STAFF RECOMMENDATION 1003 Bate Avenue July 20, 2016

Metropolitan Historic Zoning Commission
Sunnyside in Sevier Park
3000 Granny White Pike
Nashville, Tennessee 37204
Telephone: (615) 862-7970
Fax: (615) 862-7974

Application: New construction-infill and outbuilding
District: Waverly-Belmont Neighborhood Conservation Zoning Overlay
Council District: 07
Map and Parcel Number: 10509044500
Applicant: Sandi Adams, Studio S
Project Lead: Melissa Sajid, Melissa.sajid@nashville.gov

Description of Project: The applicant is proposing to construct a new one and one-half story house and detached garage that is not a detached accessory dwelling unit.

SHEET LABEL:
PROPOSED SITE PLAN

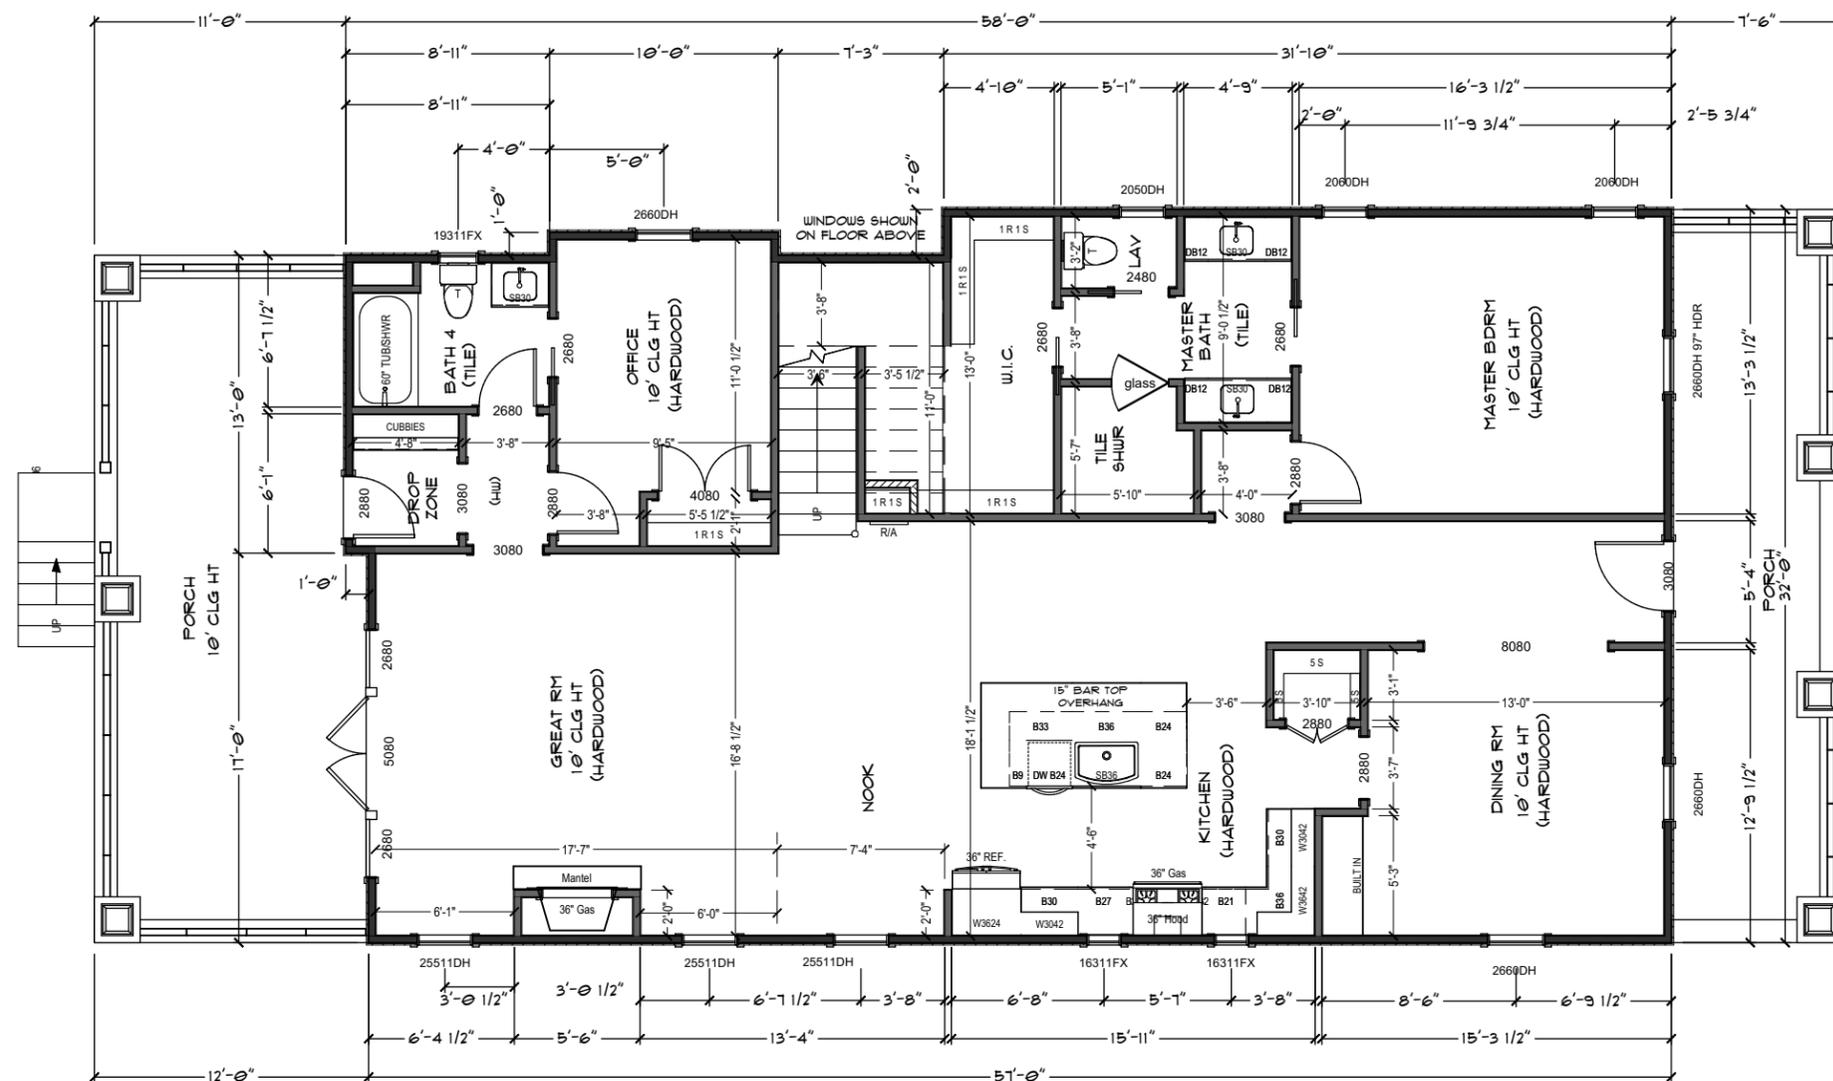
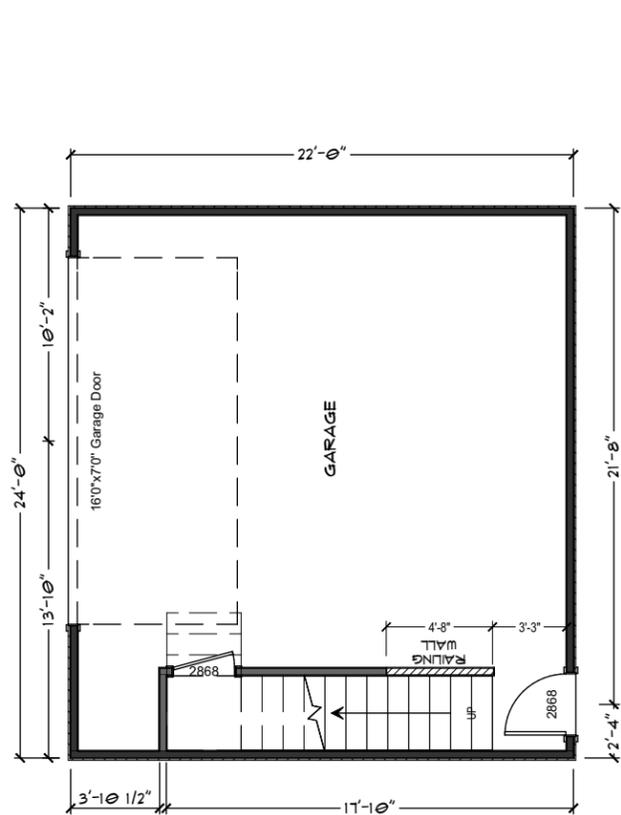
In general, an appropriate front setback is the average of the houses next door to the site. In this case, however, the houses to the left and right of the subject property are both non-contributing houses that were constructed in 1960s. In addition to being non-contributing, neither adjacent house has a front porch. Given that the proposed infill includes a front porch with a depth of seven feet, six inches (7' 6") and that the infill should meet the historic setback, staff finds that the proposed front setback of twenty-two feet (22') is appropriate for the context. Finding the proposal to be similar to the immediate historic context, staff finds the project meets section III.C.

SHEET LABEL:
FRONT, LEFT ELEVATIONS

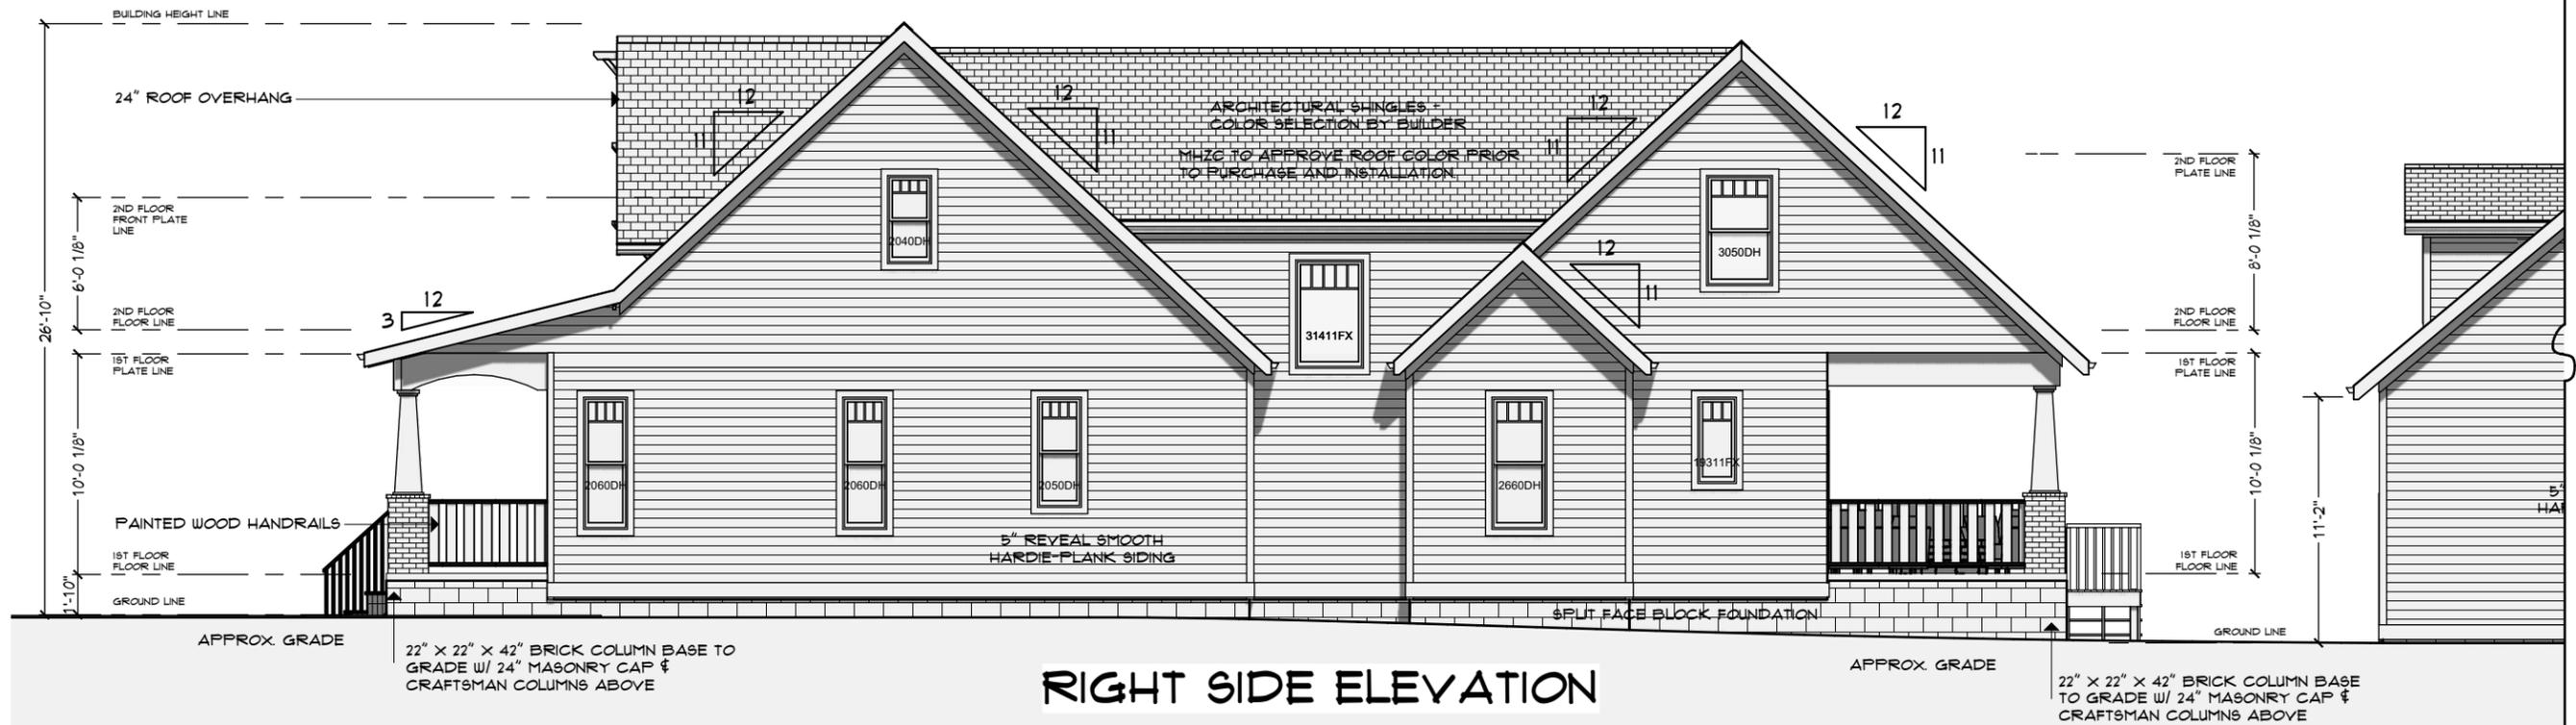
Recommend that staff verify the construction height of the foundation and floor systems in the field to ensure that the finished floor line of the new construction is compatible with the historic context.

Proportion and Rhythm of Openings: The windows on the proposed addition are all generally twice as tall as they are wide, thereby meeting the historic proportions of openings. There are no large expanses of wall space without a window or door opening. Staff finds the project's proportion and rhythm of openings to meet Section III.G.

1. The finished floor height be consistent with the finished floor heights of the adjacent historic houses, to be verified by MHZC staff in the field;
2. Staff approve the final details, dimensions and materials of trim, windows, doors, garage door, walkway, and driveway prior to purchase and installation;

SHEET LABEL:
REAR, RIGHT ELEVATIONS

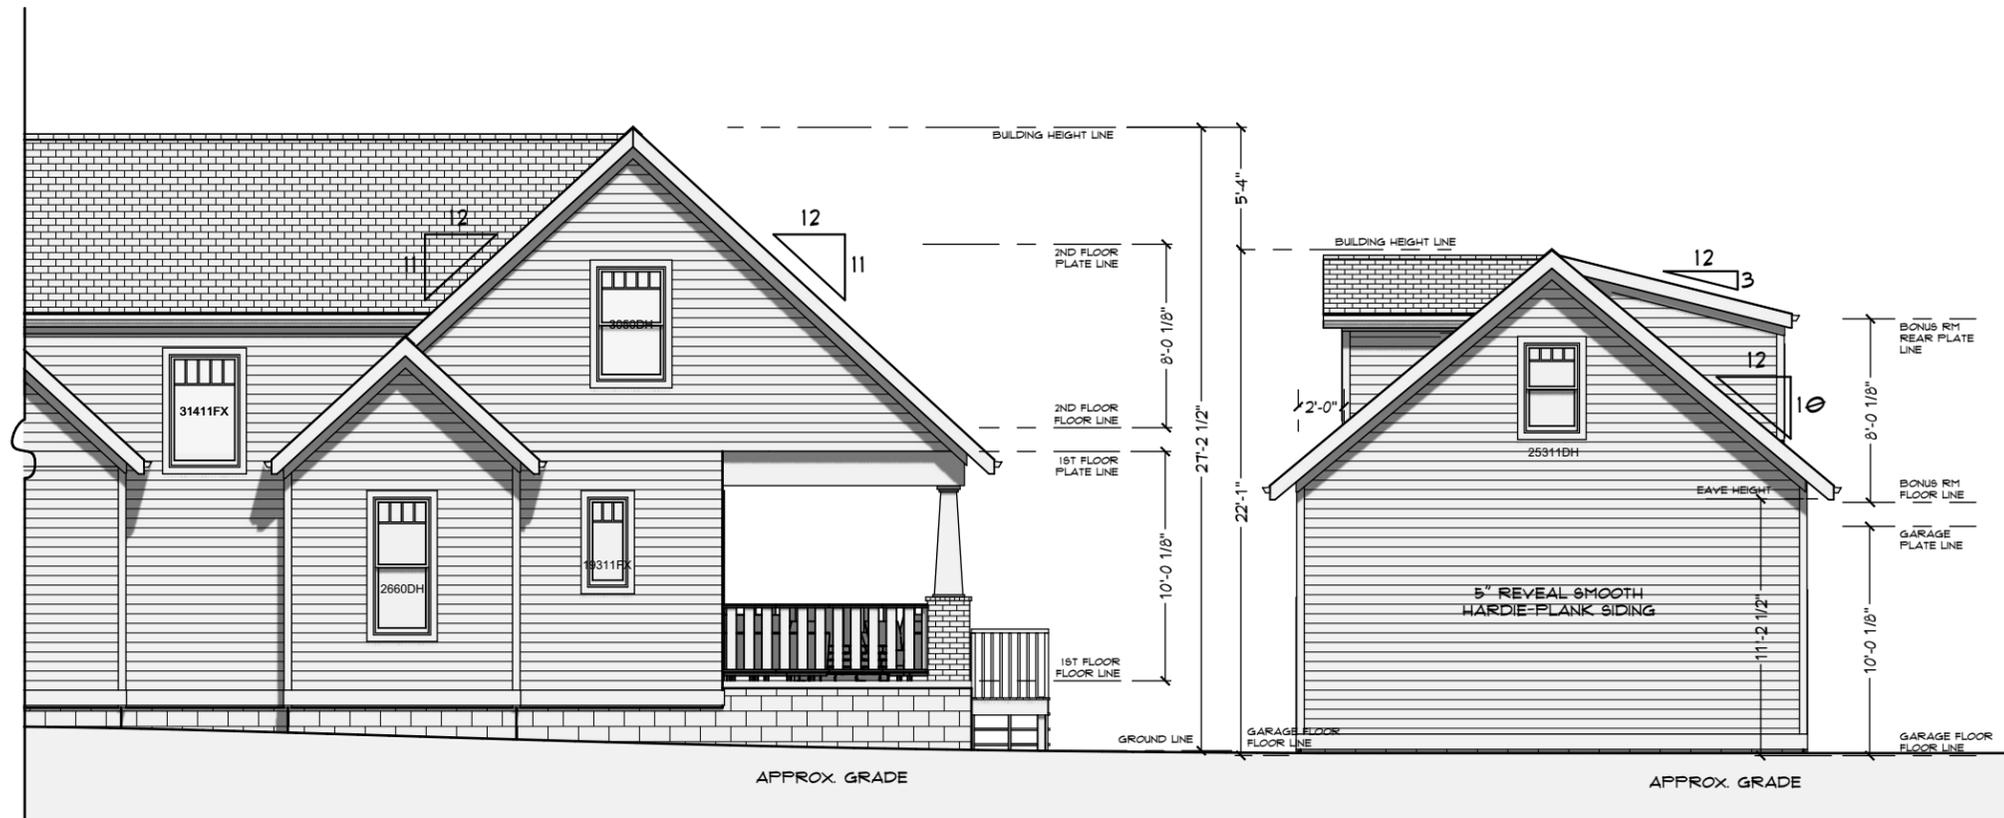
Staff recommends a condition that the HVAC be located on the rear façade, or on a side façade beyond the midpoint of the house. With this condition, the project meets section III.I. and J.

3. The HVAC be located behind the house or on either side, beyond the mid-point of the house; and
4. Staff approve the roof color, dimensions and texture.
